HISTORIC AND DESIGN REVIEW COMMISSION

HDRC CASE NO: 2018-507
ADDRESS: 614 BARBE ST
LEGAL DESCRIPTION: NCB 2912 MARIA C GUERRA SUBD, BLOCK 1 LOT 24
ZONING: RM-4, H
CITY COUNCIL DIST.: 1
DISTRICT: King William Historic District
APPLICANT: Christine Jacques
OWNER: Christine Jacques
TYPE OF WORK: Exterior modifications to two, rear accessory structures
APPLICATION RECEIVED: September 4, 2018
60-DAY REVIEW: November 3, 2018
REQUEST:

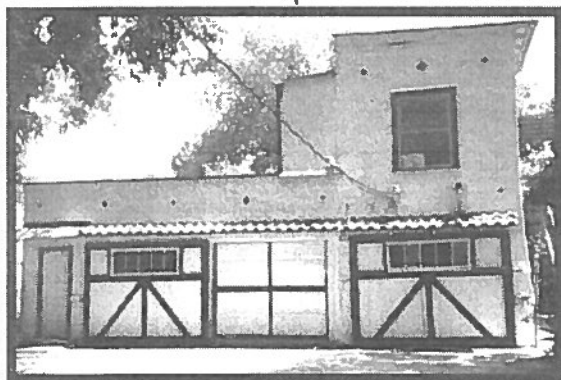
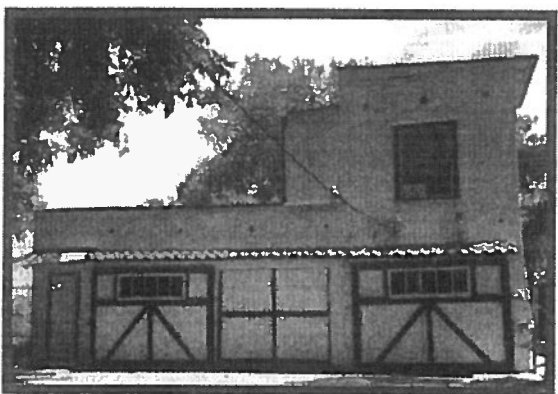
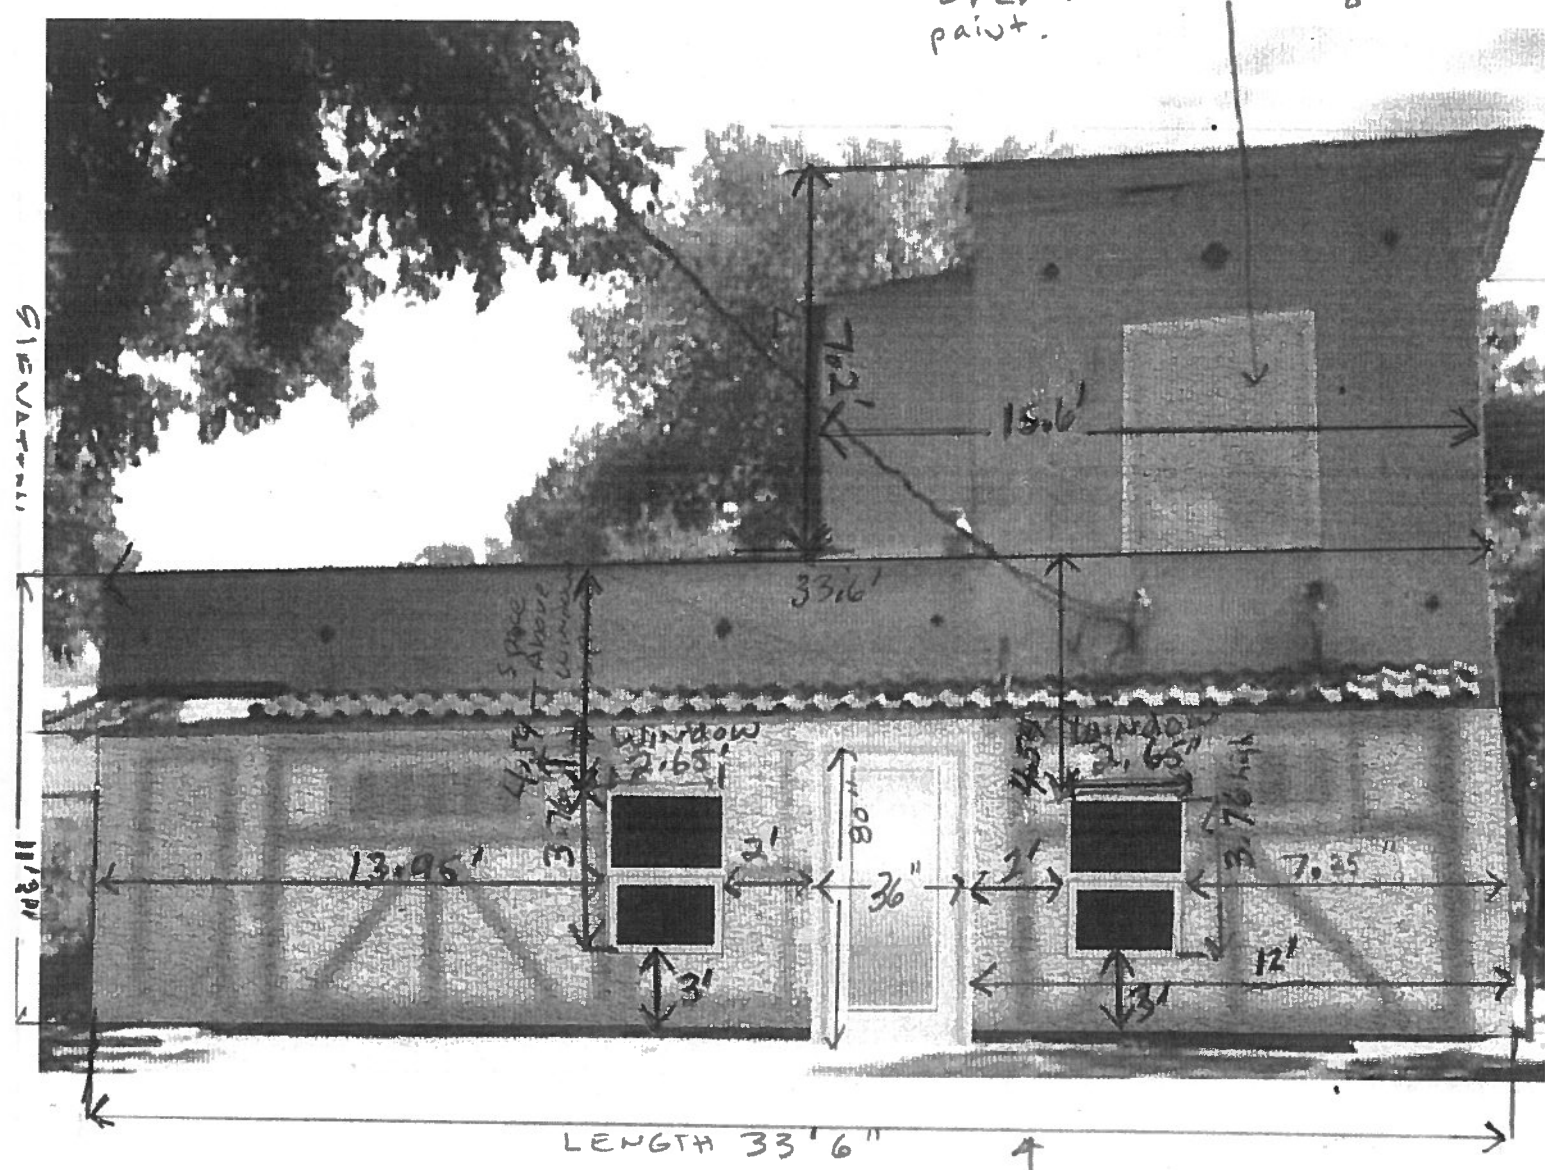
- c. NORTHERN REAR GARAGE – The structure is primarily a single-story garage with partial second-story dwelling unit as first depicted on the 1951 Sanborn map. The structure features a stucco façade, two wood carriage doors flanking a centered traditional garage door, a door at the northern corner, a second-story front façade window, and a meta staircase providing access to the second-story dwelling unit. The structure also features a rear portion with asbestos siding covering wood lap siding. The applicant is requesting to replace two existing wood carriage doors with two new vinyl windows and infill with stucco matching the rest of the façade. Additionally, the applicant has requested to remove the existing north corner door and install a new steel door with full light in a central location. While the structure has been subject to non-conforming alterations, staff finds that the proposed modifications would further detract from the primary historic structure, the other historic accessory structure, and are inconsistent with the Guidelines for Exterior Maintenance and Alterations. Staff also finds that the submitted documents are insufficient for final approval.

- d. WINDOW REMOVAL – The applicant has proposed to remove an existing, front-facing window on the second-story dwelling unit and infill the opening with stucco to match the rest of the facade. Staff finds that the proposed window removal would create a second-story wall plane that lacks fenestration, which is atypical of the historic development pattern found in the district. The proposed modifications are inconsistent with the Guidelines for Exterior Maintenance and Alterations.

34'6" length of Building
 Windows 36"x48" aluminum frame.
 (view 1)
 Door 36"x80" Glass + steel prehung door
 Remove upper window + stucco

Existing Window to be stucco over with matching stucco paint.

THE GARAGE DOORS, entrance door + upper win will be gotten rid of. 2'x4 wood placed in 16" center for all openings then covered with treated wood. Finally, Stucco will be applied to match the original stucco painted white to match.

- 1. Staff does not recommend approval of item #1, the modifications of the fenestration of the rear right accessory structure based on finding b.
- 2. Staff does not recommend approval of item #2, the modifications of the fenestration of the rear left accessory structure based on finding c.
- 3. Staff does not recommend approval of item #3, window removal on the rear left accessory structure based on finding d.
- 4. Staff does not recommend approval of item #4, applying new stucco to the covered porch based on finding e. The applicant is eligible for administrative approval to repair the existing stucco in place; however, the shape of the historic front porch arched opening must be retained.

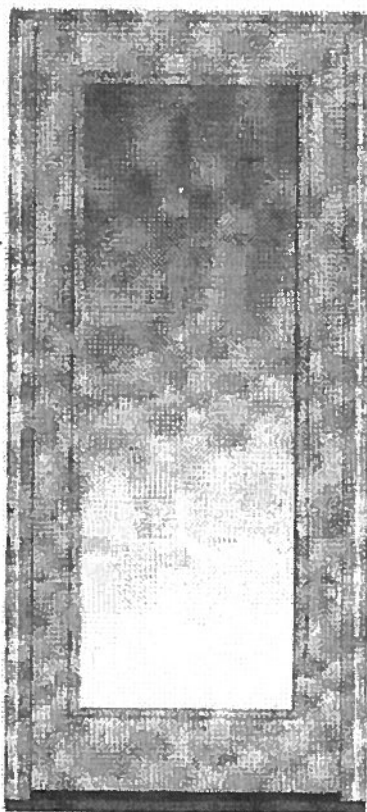
- b. SOUTHERN REAR GARAGE – The structure is a single-story garage featuring vertical Hardi siding, a primary front-facing gabled roof featuring composition shingles, a side addition, a wood-paneled garage door, two doors and a window, each covered with burglar bars. The structure first appears on the 1951 Sanborn map. The structure that once featured a covered parking area has been in-filled to feature the side-facing wooden garage door. The applicant is requesting to replace the existing garage door with two new vinyl windows and infill with Hardi board siding on the side elevation of the rear right accessory structure. While the structure has been subject to non-conforming alterations, staff finds that the proposed modifications would further detract from the primary historic structure, the other historic accessory structure, and are inconsistent with the Guidelines for New Construction 5.A. Staff also finds that the submitted documents are insufficient for final approval.

Windows vinyl 24" x 36"
Hardiebacker siding in white paint!

Remove Garage door + replace with hardie backer board that matches the remaining building. $2 \times 4 \times 8'$ boards placed at 16" centers to support hardie board. Paint white to match
